MEMORANDUM

Re: **Duke Realty Bayonne Urban Renewal, LLC**
Preliminary and Final Site Plan, Bulk Variances
TRC 23-633 Meeting Report
Block 478, Lots 1, 1.01
Block 466, Lots 1, 2, 3, 4
Block 465, Lot 9
E 22nd Street and Avenue J
Central Constable Hook Redevelopment Plan Area

Date: July 14, 2023

TRC MEMORANDUM AND VARIANCE REVIEW |
DUKE REALTY BAYONNE URBAN RENEWAL, LLC

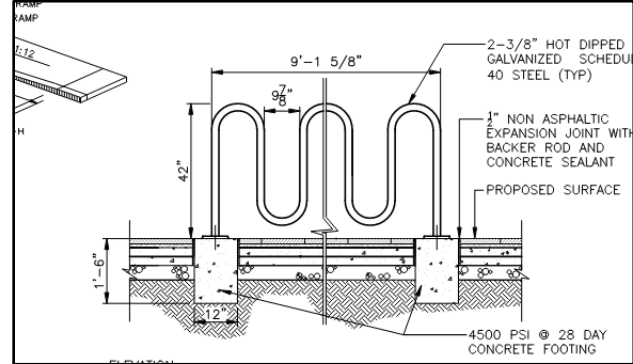
2.11. **Barrier Free Parking Space Dimensions.** Pursuant to §2.4.2c, barrier free spaces are to be provided in accordance with the American with Disabilities Act (ADA).

- 2.II.1. Parking lots with 501 – 1,000 parking spaces are required to develop 2% of all spaces as ADA spaces. The applicant proposes 932 spaces, requiring 19 barrier free spaces. 32 barrier-free spaces are provided. The plan complies.
- 2.II.2. Van accessible spaces are required to be 132 inches wide with a 60 inch wide access aisle. All van accessible spaces comply and are 11 feet wide with 60 inch wide access aisles.
- 2.II.3. Car accessible spaces are required to be 96 inches wide and contain a 60 inch wide access aisle. The car accessible spaces are all 96 inches wide and contain a 60 inch wide access aisle. The plan complies.

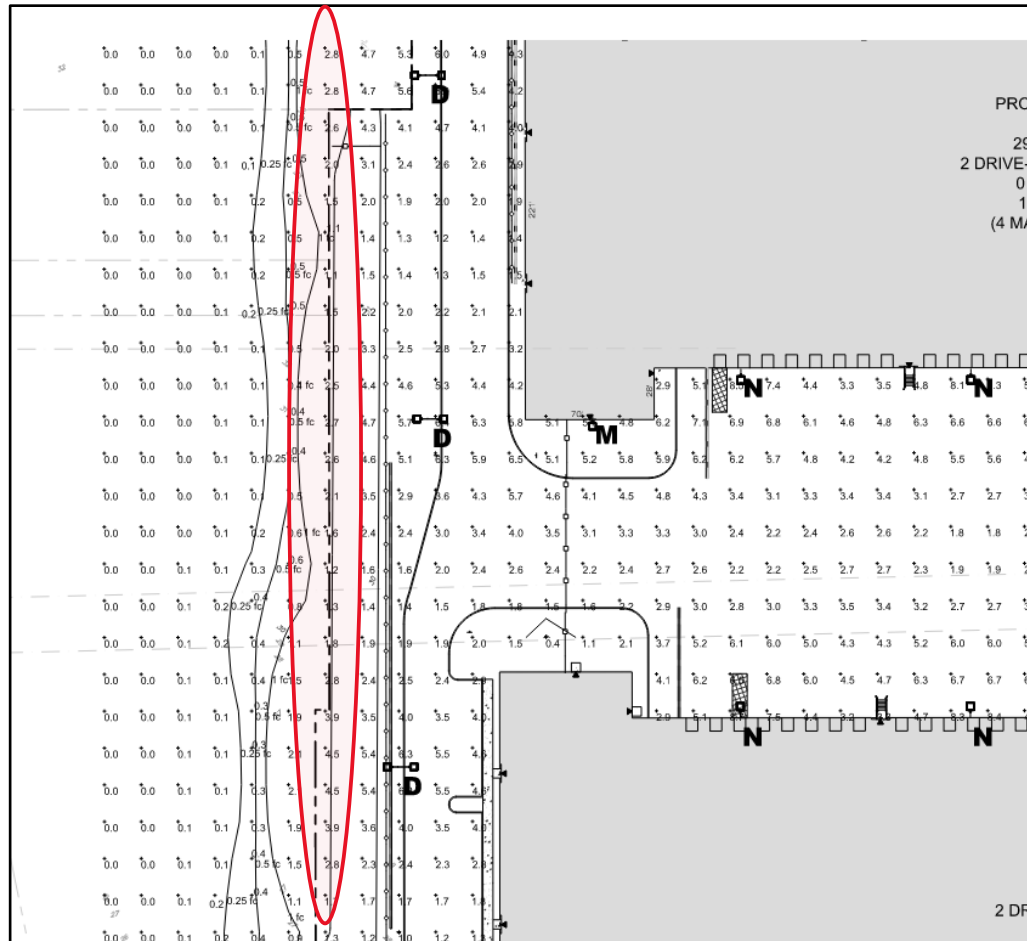
As indicated in the image on the following page, it does appear that the property boundary to the west of buildings 2 and 3 has light spillage in excess of one footcandle. This may be for security reasons, which is permitted, however testimony to that effect is required. **The applicant will require variance relief unless testimony or other information submitted indicates that this is a security requirement.**
